SIB 11 10 21

RECALL 21V-907: EXHAUST GAS RECIRCULATION (EGR) COOLER – N57T LOW TEMPERATURE

This Service Information Bulletin (Revision 4) replaces SI B11 10 21 **dated October 2022**.

What's New:

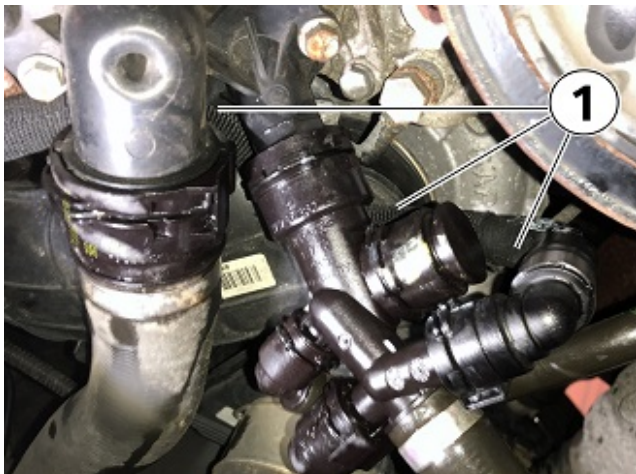
Hint: Record or take a photo of the following numbers on the new EGR cooler before installation (1, 2 and 3). These numbers will be required later to register the new cooler in ISTA.

1. Production date [YY-MM-DD]
2. Revision index
3. Serial number
